Chingleput Division Office.

With reference to your No. 2259 dated 11th August 1890 I have the honor to forward herewith for your information and early return, two measurement books regarding the Vayalur Salt Factory Flood Bank, from which it will be seen that the excess of 7246 c yards of earthwork in excess of the estimated quantity is not due as you seem to think to an incorrect estimate or to incorrect measurement.

Voyalur Salt-Factory.
flood banks.

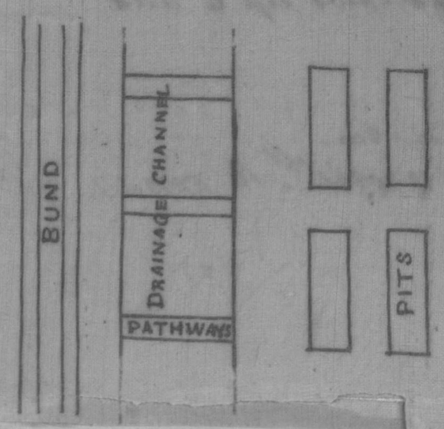
2. From the diagram in the margin it will be seen, that pits had to be dug in the high ground opposite the Bank and earth had to be carried through the trench between the high ground and the salt pans. The foot paths were therefore essentially necessary and bunds had therefore to be construc-

Constructed for the purpose of carrying the excavated soil across the trench to the embankment. When preparing the estimate the necessity for these paths was not foreseen as however might have been done.

These small bunds had, after they had served their purpose, to be removed so that the trench might be open to receive drainage for which it is intended. This entailed extra expence.
